SOUTH TEXAS PROJECT

RESPONSE TO REQUEST FOR ADDITIONAL INFORMATION

PROPOSED AMENDMENT TO ALLOW USE OF ELBOW TAP ΔP s TO MEASURE

REACTOR COOLANT SYSTEM FLOW RATE

FIGURE 1
RCS HYDRAULIC NETWORK DIAGRAM

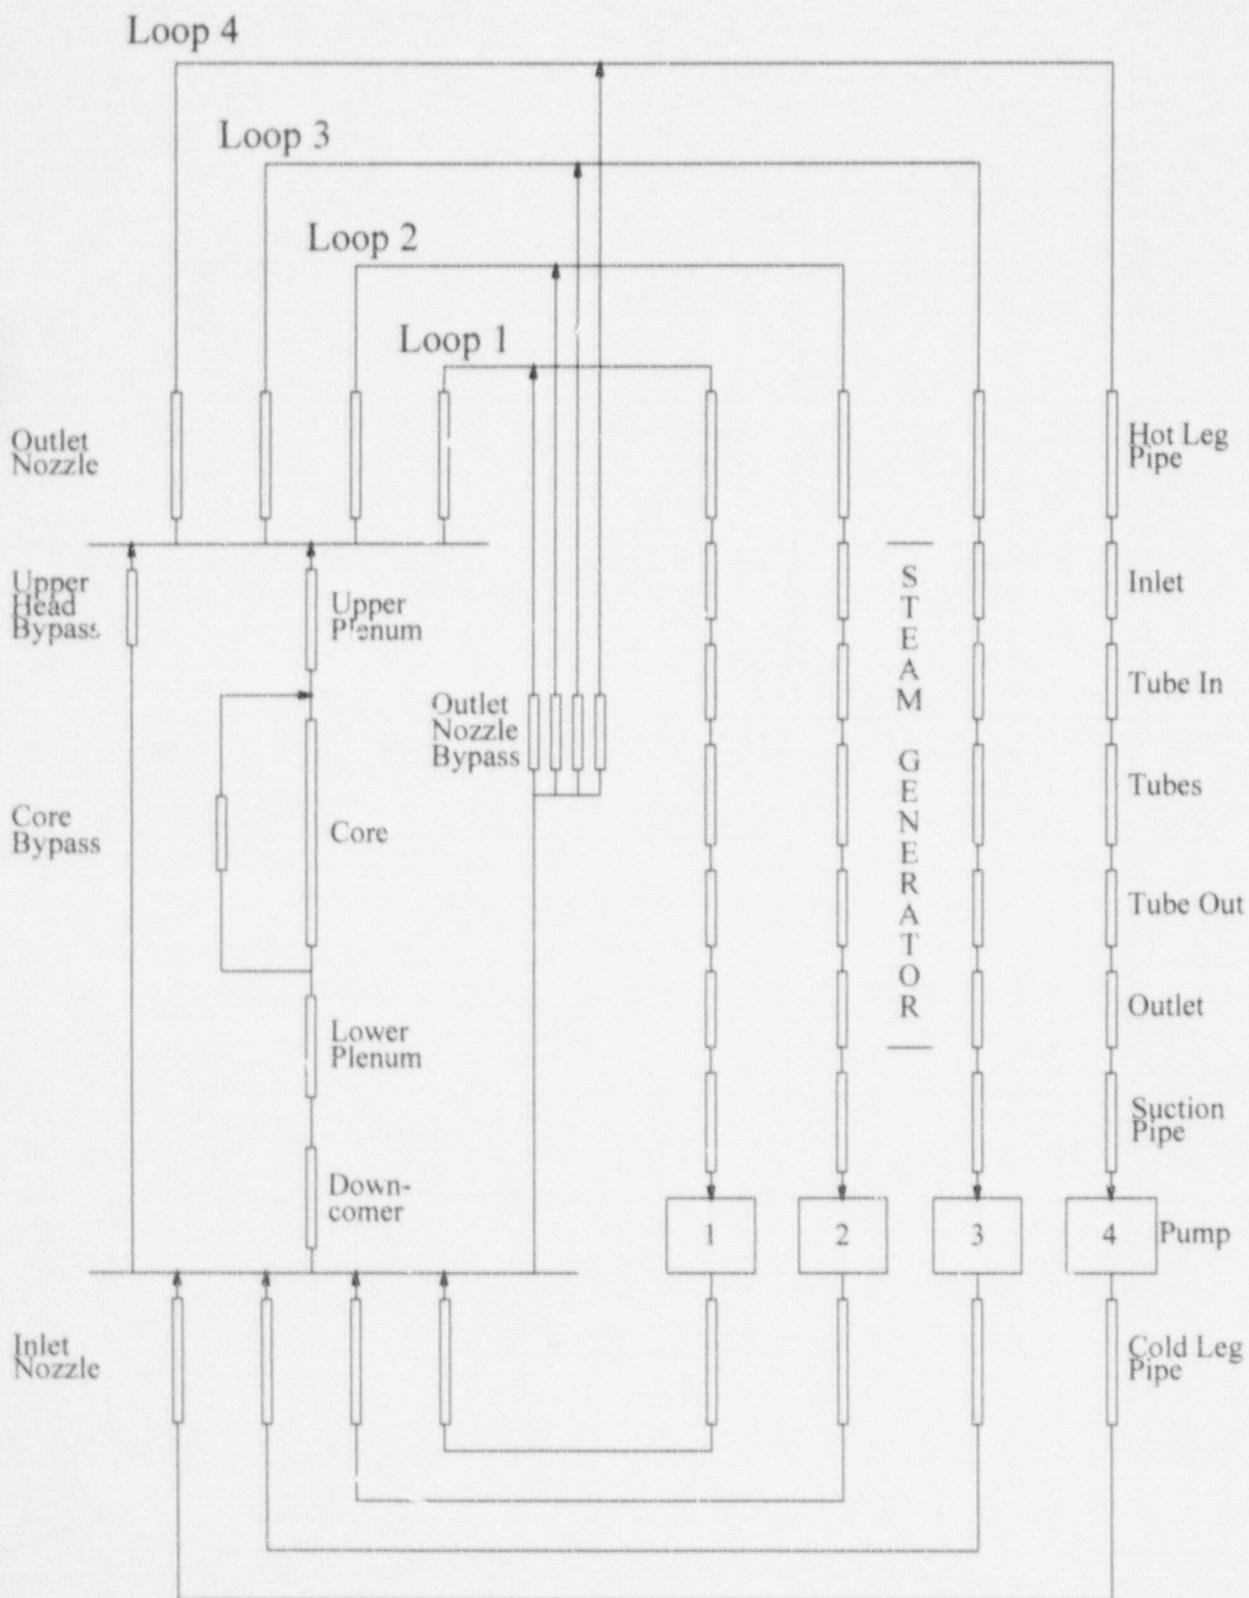
1. Provide the analytical model used including nodalization diagram, equations used, etc.

RESPONSE: The RCS hydraulic network diagram for the best estimate flow analysis applied to the South Texas Project is shown on Figure 1. The network consists of two major parts: reactor internals and reactor coolant loops. These flow paths and flow resistances are described below.

The major flow path through the reactor internals from the vessel inlet nozzles to the vessel outlet nozzles, shown on Figure 1, is through the downcomer, lower plenum, reactor core and upper plenum. Figure 1 also shows small flow paths which bypass the reactor core: the core bypass flow through the control rod drive thimbles and the gap between the internals barrel and core baffle, the bypass flow through the vessel upper head, and the bypass flows through the vessel outlet nozzle gaps. These bypass flows for the South Texas Project units are conservatively estimated to be 4.5% of total flow, so 95.5% of the total flow is the effective heat transfer flow through the reactor core.
